**Response to Public Comments  
on the Environmental Assessment  
for the New Source NPDES Forest Oil Redoubt Shoal Unit  
Production Oil and Gas Development Project  
NPDES Permit No. AK0053309**

**INTRODUCTION**

Figure 2-3. Process Flow Schematic for Osprey Platform Production Operations.

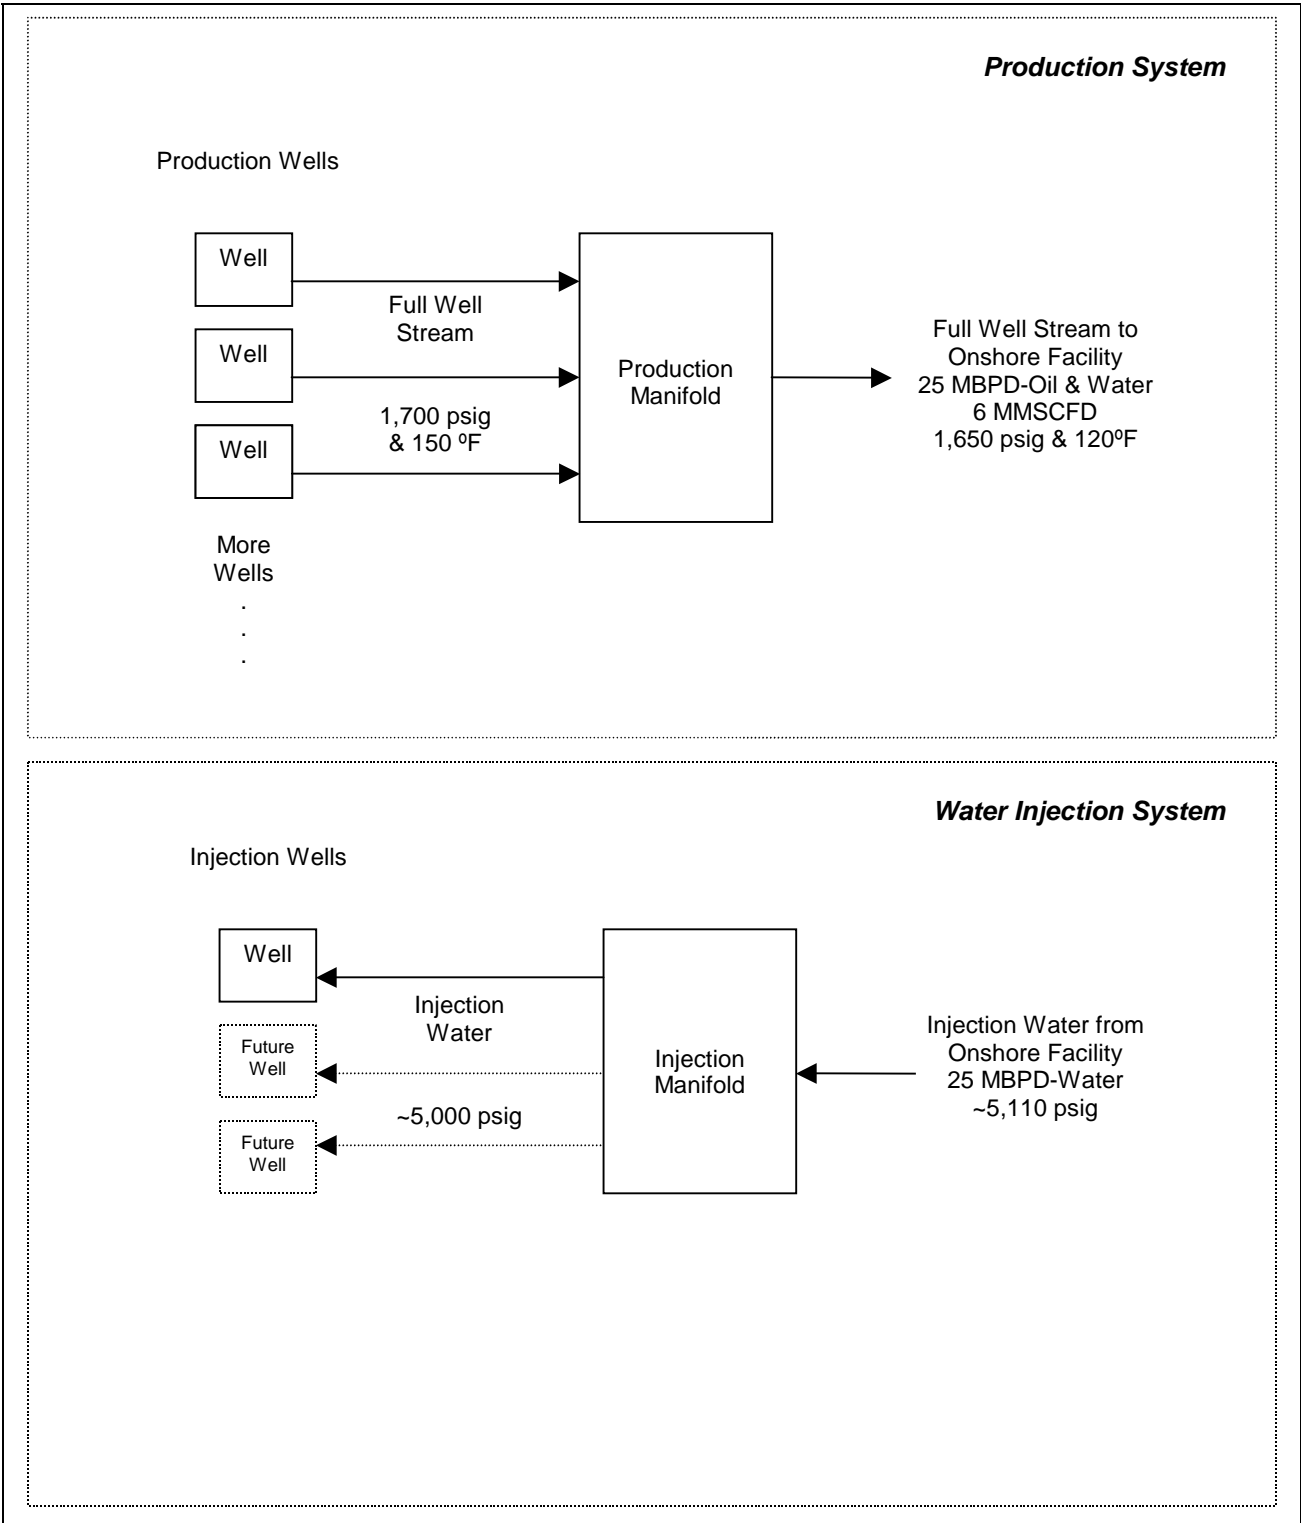
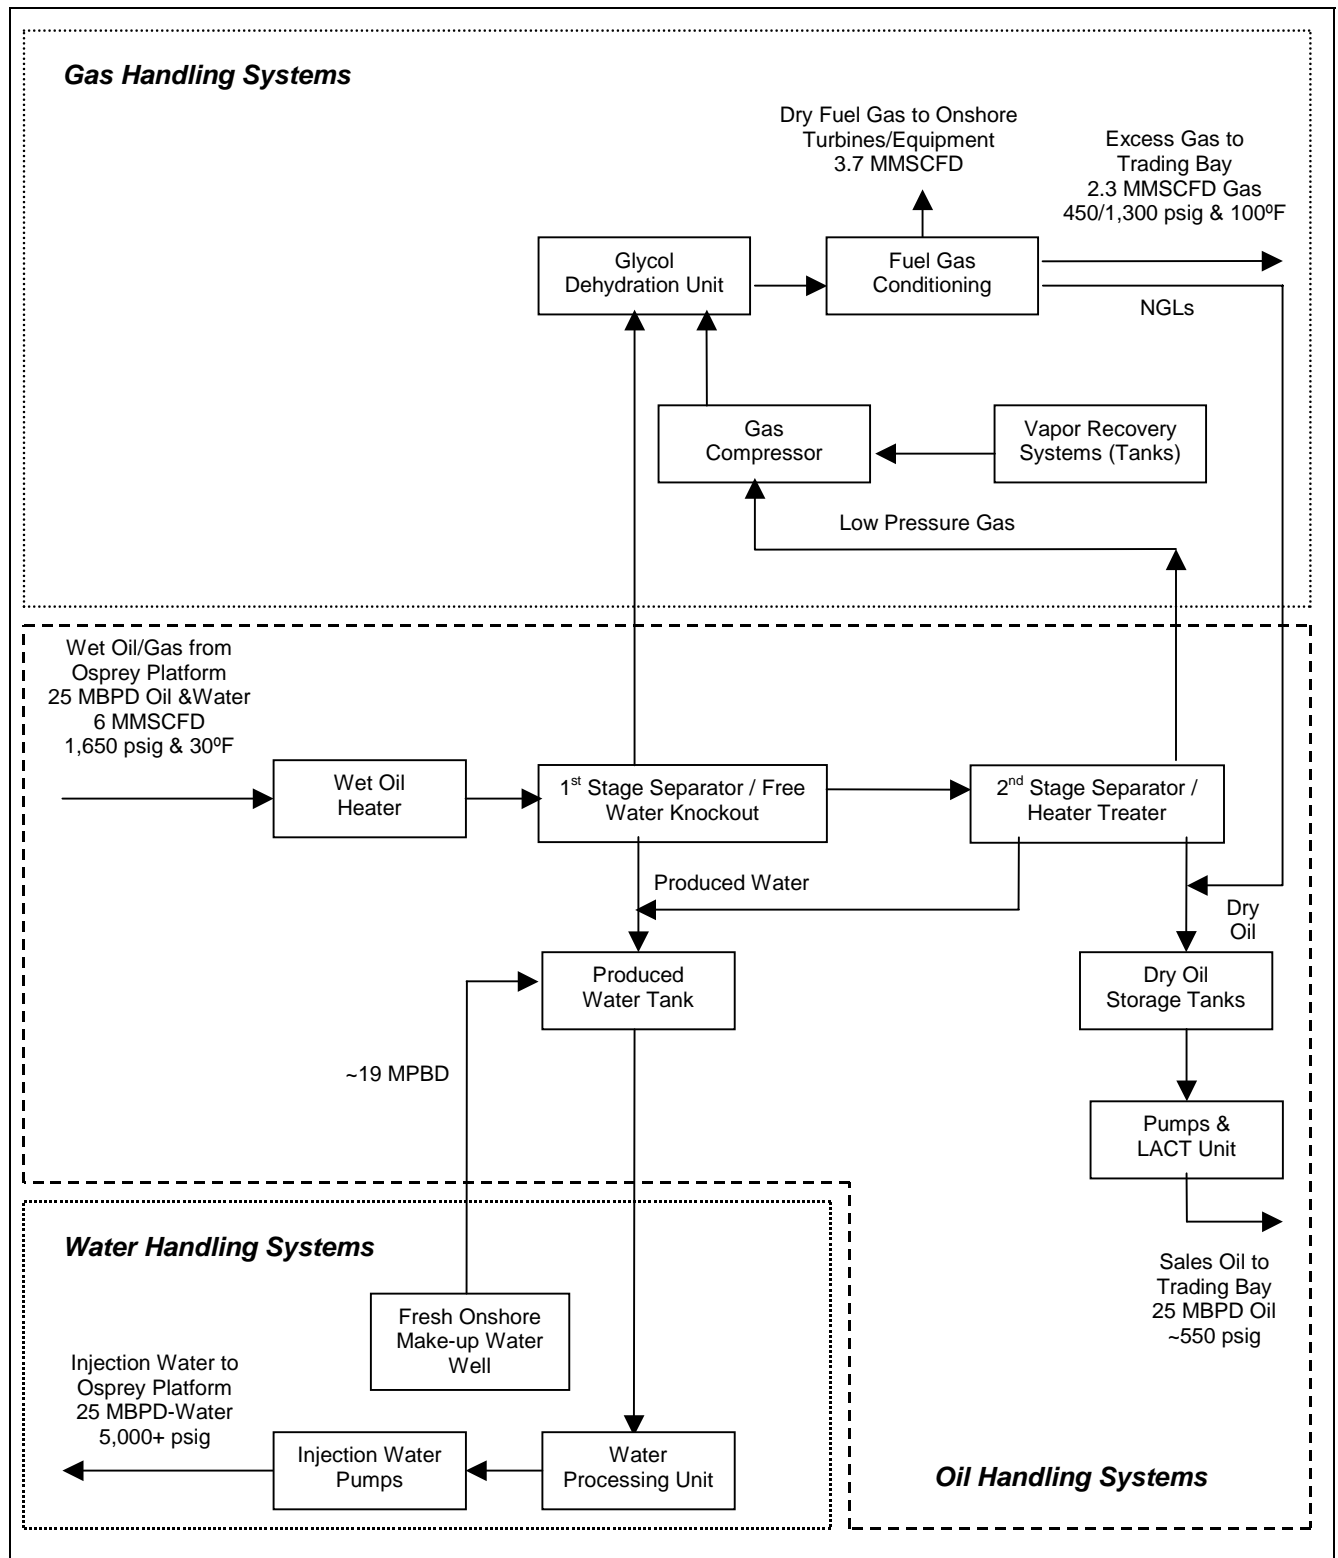
Description of Project Alternatives	b	1	The EA fails to adequately provide an up-to-date description of proposed activities, including detailed schematics, process flow diagrams and other necessary information to understand the environmental consequences posed by the proposed project. The EA is unclear whether bluff augering or trenching will be used for pipeline placement.	Process flow schematics of the Osprey Platform and Kustatan Facility production operations have been revised and are provided as Attachments A and B to this Response to Comments. At the time the EA was prepared, the applicant proposed trenching as the preferred alternative. Therefore, EPA evaluated the applicant's preferred option of trenching. As defined on page 2-7 of the EA, the proposed project assumes that the nearshore pipeline will be placed by trenching and cutting through the intertidal/shallow subtidal area and through the bluff. Potential environmental impacts have been described for this option. Bluff augering may be determined to be technically feasible; if this option is implemented, environmental impacts would be lower than those described for the proposed project, particularly for nearshore sediments, water quality, and benthic marine organisms.
